GLA-1000B S

Cathode Current Cutoff Modification by Skipp May wv6f
nospam4me@juno.com

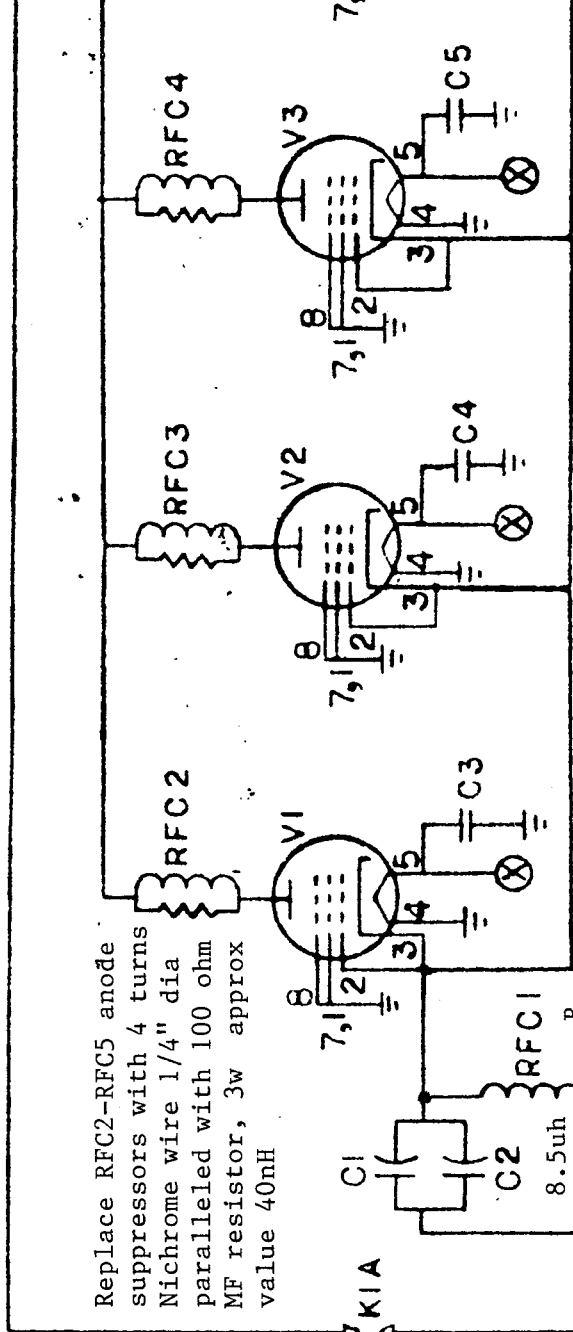
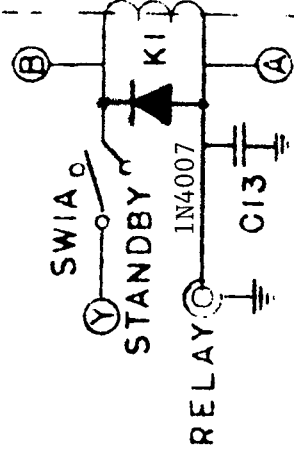
Original Dentron tubes D-50a
Replace with NOS 6LQ6/6JE6
or retrofit with EL-509 by
Svetlana

Replace RFC2-RFC5 anode
suppressors with 4 turns
Nichrome wire 1/4" dia
paralleled with 100 ohm
MF resistor, 3w approx
value 40nH

add diode across K1

Original relay unused contacts (center) used
to short Rc (75k lwt) in transmit mode.

24 volt zener, stud mount.
